# Kiltiernan SHD

## Lands at Wayside, Kiltiernan

Quality Audit

Stage 1 Road Safety Audit

Figure 2-3 – Path between Cell 8 and 9

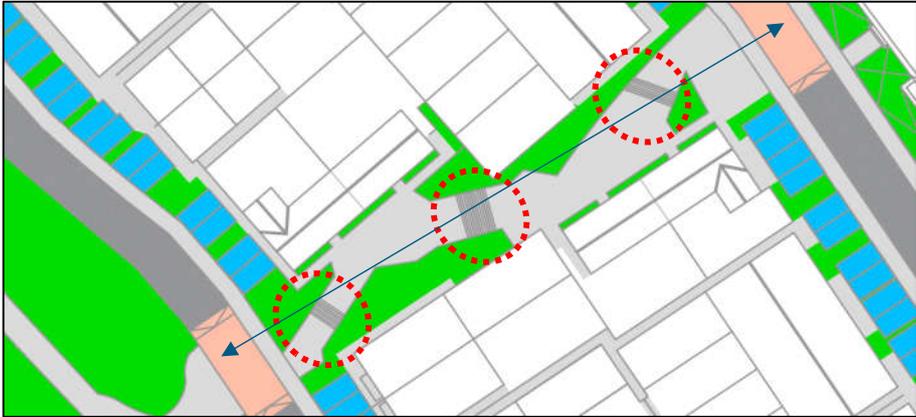
A series of stairs are indicated between housings cells 8 and 9. It is not apparent how wheelchair users would travel along this part of the scheme and between the adjacent roads.

The Designer should consider the movement of wheelchair users in the location described is adequately considered.

2.3.4	Y	Y	DDA compliant route is provided to all dwellings and from dwellings to car parking areas. Area will be further reviewed at detailed design to optimise access further.

**Figure 3-1 – Signalised Pedestrian Crossing**

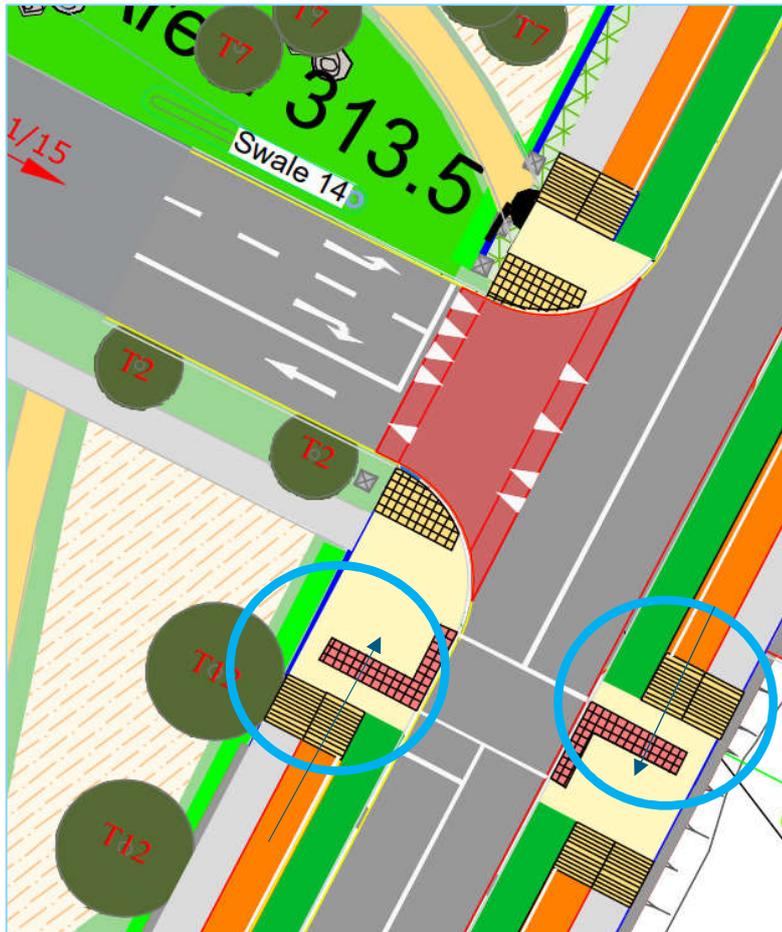
The drawings indicate that cyclists will be entering a shared area directly adjacent to the pedestrian waiting area of the signalised pedestrian crossing. There is a risk of conflict between cyclists and visually impaired pedestrians or people who may be pushing buggies as they have limited opportunity and space to avoid each other.

The Designer should increase the length of the shared area to ensure cyclists have enough time to slow down or dismount and account for pedestrians waiting in the areas highlighted.

3.1	Y	Y	Details will be changed/finalised at detailed design.	
3.2	Y	Y	Provision provided	
3.3	Y	Y	Shared area to be extended to allow for access and reduce conflicts and provide appropriate path for entry and exit of cyclists to the scheme.

**Figure 3-2 – Internal Junction**

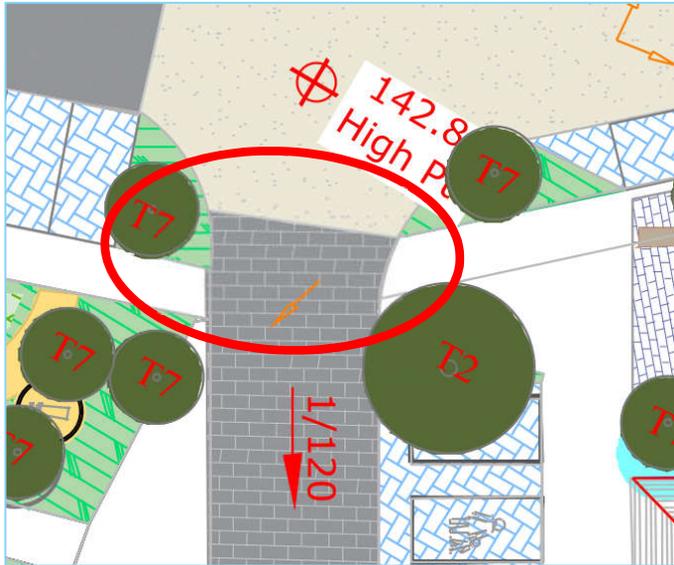
The design drawings do not indicate warning measures at various locations across the scheme. An example of this is the crossing point at the north-east corner of the Village Green. This may result in pedestrians entering the roadway without warning which may result in pedestrian / vehicle collisions.

There are multiple other locations where suitable guidance / warning has not been provided and may lead to conflict where less abled users / visually impaired are not suitably warned.

The Designer should ensure adequate warning features are provided on all desire lines, at the junction crossing points and interface between shared use zones and footpaths throughout the scheme.

**Figure 3-3 – Cyclist access through junction 1**

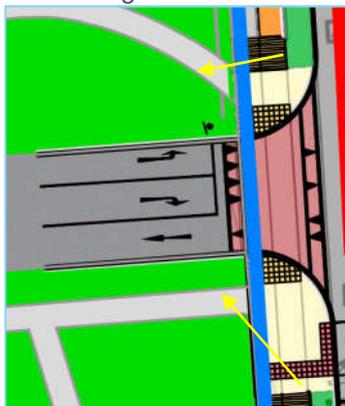
The proposals do not indicate how cyclists will enter and exit the development on the east through Junction 1. This may lead to pedestrian / cycle conflict.

The Designer should ensure that cyclists can enter and exit the development while considering the movement of pedestrians across the junction.

Figure 3-4 – Access points to buildings along west of scheme

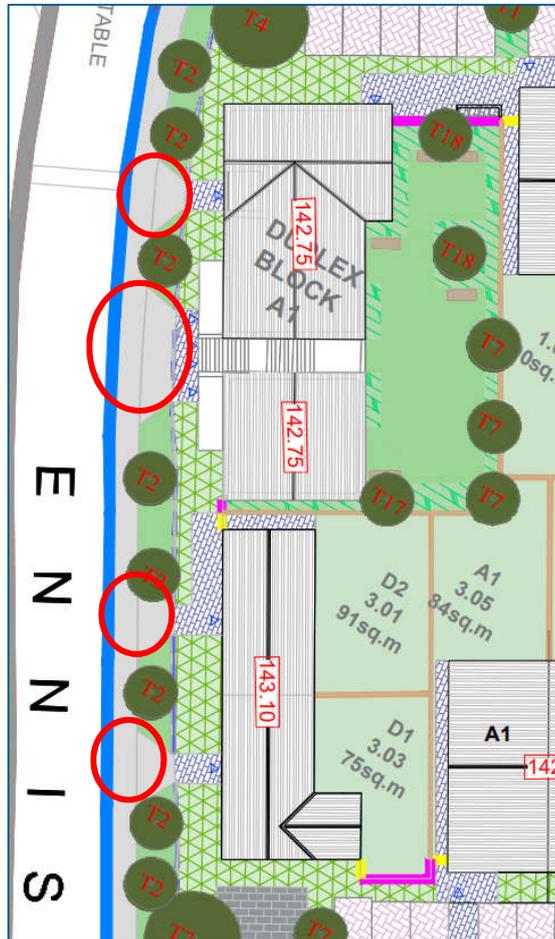
The drawings detail pedestrian entrances into Duplex Block A1 opening directly onto the Enniskerry Road. There is potential for drivers to mount the kerb and park within these areas, leading to potential conflicts with pedestrians.

Consideration should be given to deliveries and visitors in and out of the complex. The designer should consider measures to deter vehicles from parking in these areas.

3.4	Y	Y	A full height kerb with no drops(upstand 125mm) is proposed along Enniskerry Rd that will prevent/discourage cars from mounting the kerb. Appropriate Traffic Regulation

Orders and ban on “wheel stoppers” will be implemented. Parking for these units on Enniskerry Road is provided to the rear. This includes provision for visitor car parking and servicing.	
3.5	Y	Y

Figure 3-5 – Junction 16 Alignment

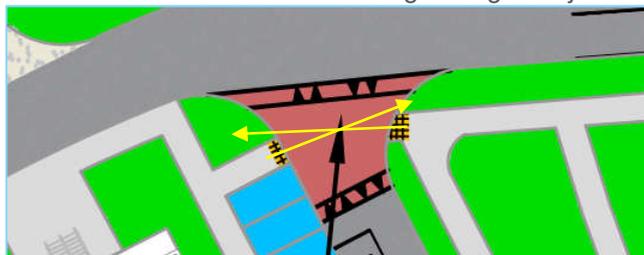
The angle of footpaths and tactile paving is such that users may be incorrectly directed across the junction and fail to reach the opposing footpath. This may lead to an increased risk of conflict with vehicles moving through the junction.

The layouts should be amended to have the crossing lining up directly on both sides of the junction.

**Figure 3-6 – Junction 12 stagger on crossing**

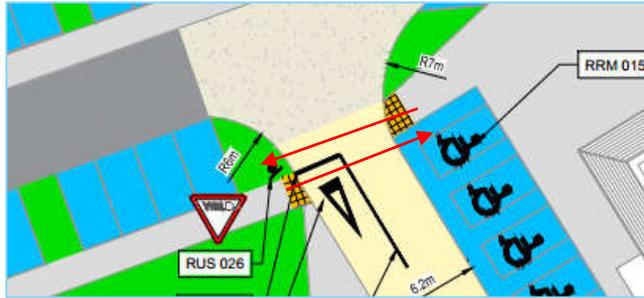
A similar concern relates to Junction 12.

Figure 2-3 – Continuity of Cyclists at Junction 1

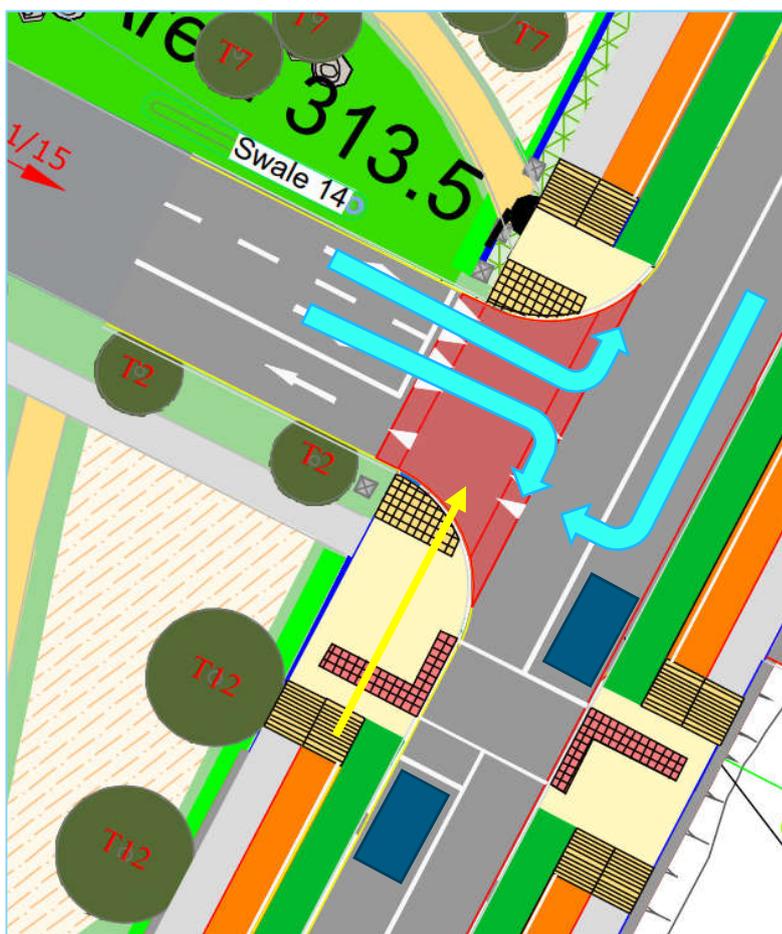
The drawings indicate cyclists will bypass the controlled pedestrian crossing and can continue through the junction while the lights may be on red. The presence of stopped vehicles at the pedestrian crossing may suggest it is safe / clear to continue however traffic may still be entering and existing the development at the same time which are unsighted/unexpected by the cyclists. This may lead to conflict between turning vehicles and cyclists.

The Designer should consider measures to address the risk of confusion and conflict noted.

2.3	Y	Y	A review of junction at detailed design will be undertaken and the optimum layout finalised considering concerns noted.	
2.4	Y	N	Traffic flows on Enniskerry Rd will significantly reduce when the GDRS is implemented with a bus gate restricting traffic flows travelling north south through Enniskerry Neighbourhood Centre. Road has been narrowed and footpath widened and landscape improvement. Proposal will provide opportunities for multiple crossings in low traffic low speed environment.	Yes. Shift of traffic and cross section changes noted to help address concerns noted. . Designer might consider crossing of this road by all road users during the detailed design stage to and from other developments including the church.

Figure 2-4 – Junction 11

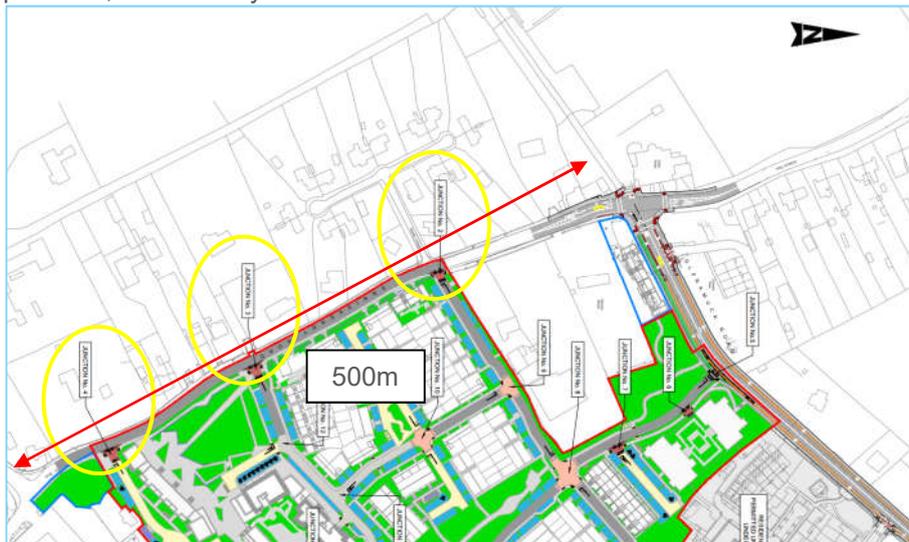
The scheme proposes 3 junctions on the west along the Enniskerry Road. Crossing provision for pedestrians, cyclists and less abled user have not been detailed in the scheme proposals. The existing Enniskerry Road was observed to have relatively frequent traffic travelling at moderate speed. The nearest crossings are located at the village of Kiltarnan at Farmer Brown's public house and the Circle K further south which are approximately 500m apart. It is unlikely that people will utilise these to cross the road and attempt to cross the road closer to Junctions 2, 3 and 4. Where adequate provision is not provided, conflict may arise.

The Designer should assess the scheme proposals in the context of likely desire lines across Enniskerry Road and propose measures that would cater for desire lines and demand. The provision of a crossing(s) would also likely contribute to calming traffic speed along the road in addition to providing appropriate crossing opportunities for less non-motorised users.

Figure 2-5 – Alignment Through Junction 8

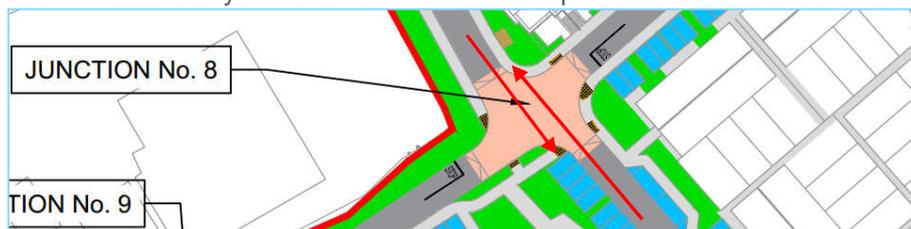
The north-south alignment includes a relatively sharp change/kink. Drivers may find it challenging to negotiate the junction and opposing traffic with the degree of stagger indicated. This may lead to conflict such as swipe and head-on collisions.

The Designer should review the extent of stagger proposed and allow a smoother movement of traffic in the 'main' north-south flow of traffic.

2.5	Y	N	Alignment of road has been developed to encourage low speeds in accordance with DMURS principles of self-regulating streets. Stagger will encourage lower speed and will provide pedestrian priority	Yes. Designer notes the layout is in keeping with design intent.

Figure 2-7 – Adjacent Junction 16

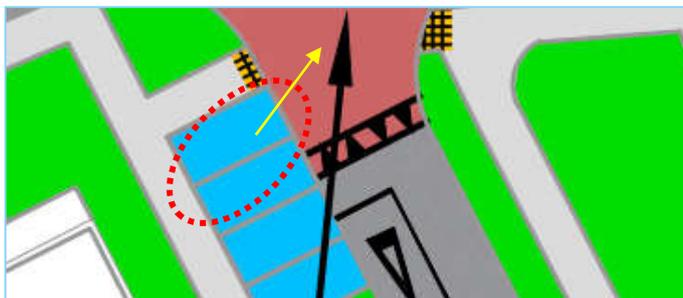
Parking is indicated directly adjacent to pedestrian crossings. This may result in vehicles restricting visibility of people wishing to cross the junction. Additionally parked vehicles may need to reverse across the junction while exiting the parking locations. This may also lead to conflict.

The Designer should ensure adequate visibility is provided and sufficient space between the crossing and parking areas to allow for manoeuvring vehicles.

2.7	Y	Y	Design has been modified and car parking spaces moved away from junctions	
2.8	Y	Y	Check undertaken and vehicles do not excessively cross centre of the road.

**Figure 2-11 – Likely desire line Junction 10**

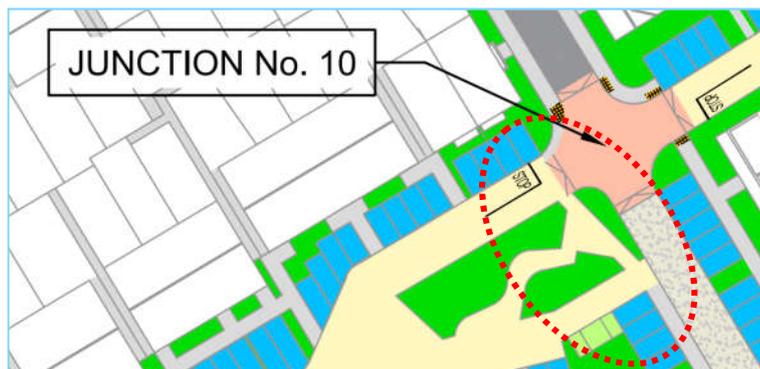
A similar concern relates to Junction 10 where a clear dedicated path for pedestrians is not evident in the design drawings.

The Designer should review the locations outlined and make adequate provision for pedestrians wishing to cross.

2.9	Y	Y		
2.10	Y	Y		
2.11	Y	Y	Design provides adequate visibility given road alignment, design speed and vehicle flows both along the local street and in particular the homezone street where there is limited traffic expected as noted in DMURS (section 4.4.5 page 109 – <i>“Designers must also take a holistic view of the application of reduced forward visibility splays as this can provide traffic calming benefits“</i>	Yes. Designer confirms that adequate visibility has been provided.

**Figure 2-13 – Parking Junction 14**

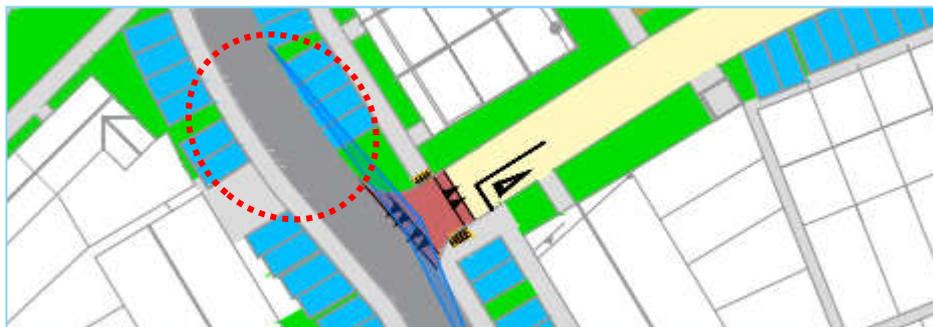
Parked vehicles are likely to compromise the visibility splay to the north of the junction. This may result in vehicles pulling out when it is unsafe to do so which may lead to conflict such as swipe, shunt and side-impact collisions.

The Designer should ensure adequate visibility is provided at the location described.

**Figure 2-14 – Parking Block C&D**

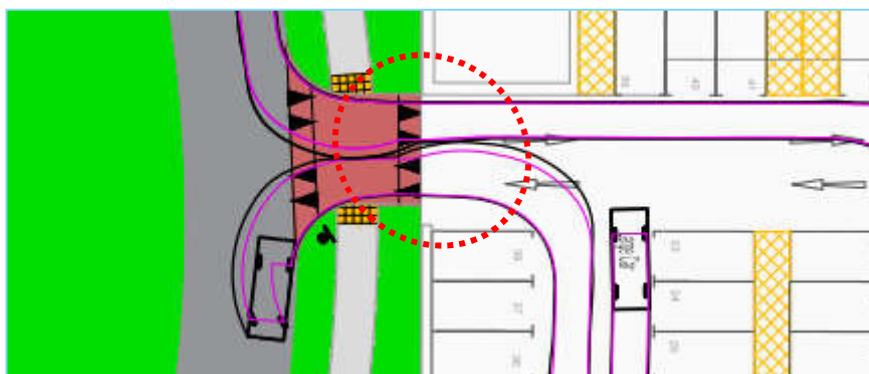
The walls serving the parking area of block C&D may compromise visibility to pedestrians crossing at the entrance / exit area. This may result in vehicle / pedestrian conflict.

The Designer should ensure adequate visibility is provided at the location described. This should include consideration to any canopies / overhangs that may be proposed for the structure that may impact on the presence of crossing pedestrians.

2.12			Visibility given road alignment, design speed and vehicle flows both along the local street and in particular the homezone street where there is limited traffic expected as noted in DMURS (section 4.4.5 page 109 – <i>“Designers must also take a holistic view of the application of reduced forward visibility splays as this can provide traffic calming benefits“</i>	Yes. Designer confirms that adequate visibility has been provided.
